**BC BUILDING CODE INTERPRETATION COMMITTEE
AIBC, APEGBC, BOABC, POABC**

Interpretation Date:	March 21, 2001	File No.
Building Code Edition:	BC Building Code 1998	98-0020
Subject:	On-site constructed fixtures	
Keywords:	On-site showers	
Building Code Reference(s):	7.2.2.3.(1)	Page No. 1 of 1

Manual Reference Section: 2	1998 Code Reference: Sentence 7.2.2.3. (1) Sentence 2.5.1.1. (1)
Date: February 21, 2001	
Interpretation No.: 2008 Revised

ON SITE CONSTRUCTED SHOWER BASE

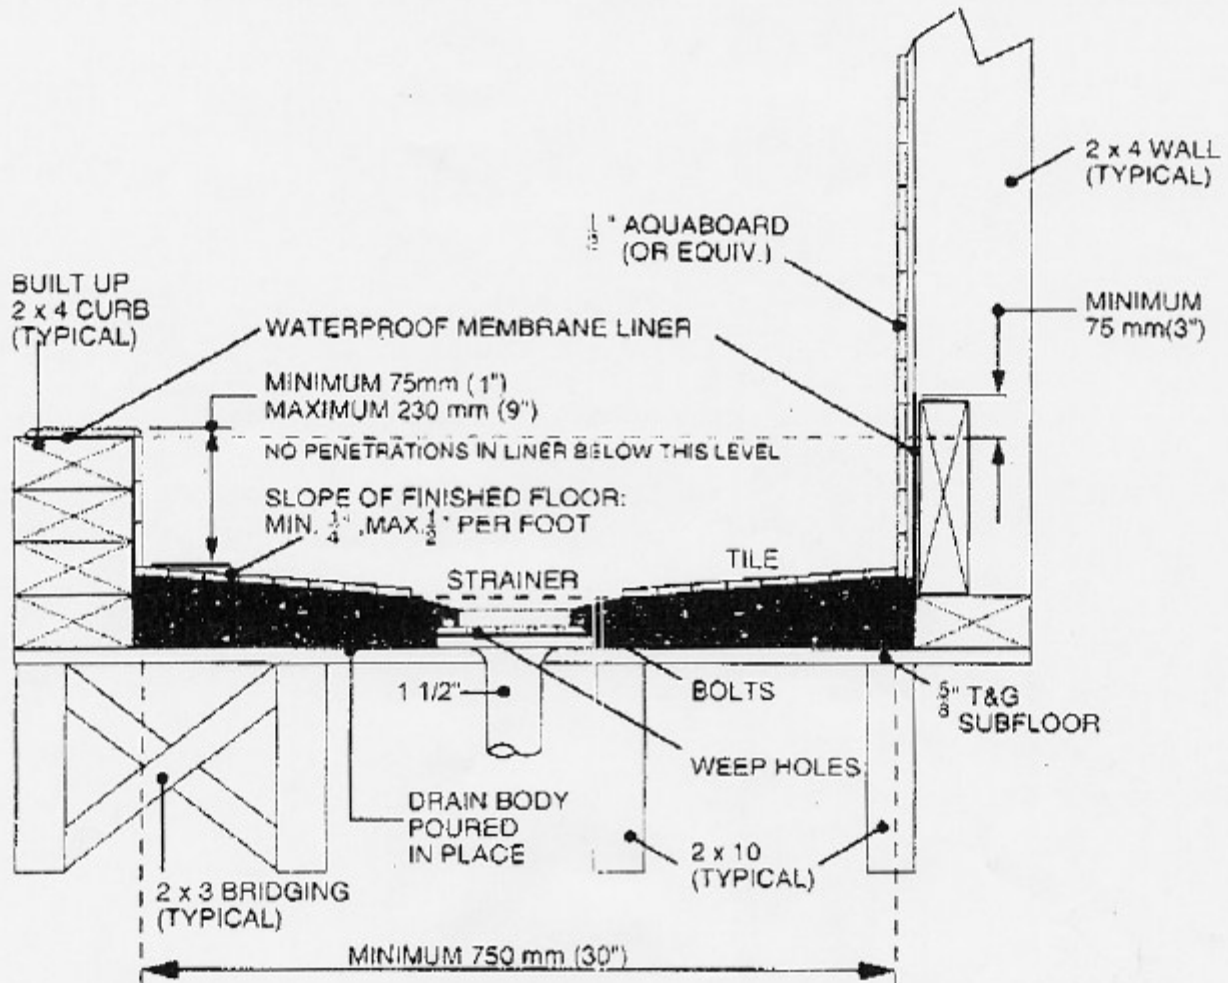
The 1998 BC Plumbing Code lacks any reference for acceptable on-site constructed plumbing fixtures. Is there a drawing available for acceptable construction?

The drawing on page two has been accepted for many years and has provided excellent durability for the user. Some consideration should be given for acceptable variations and inspections as follows:

1. The drain outlet must be minimum 1½" size and subject to sizing for number of heads served.
2. The base must be designed so that no water can accumulate between the membrane and tile surface.
3. Self draining can be accomplished by recessing the drain or sloping the floor with plywood or concrete.
4. The liner must be water tested by plugging the outlet of the drain and filling with water to threshold height. This will facilitate testing of the clamping collar below the membrane.
5. When test is removed no water should remain in the liner.
6. Weep holes to remain open by the use of cotton wicking or other effective means.

- Backing to be installed between studs to support liner.
- Weep holes must be protected from blockage.
- Liner shall be water tested to flood level rim.
- The Min. usable area shall be 580,000 sq. mm (900 sq. in) with no dimension less than 750 mm (30 in)
- No material that may be harmed by moisture shall be used inside the liner.
- A shower door shall not open inside the shower stall.
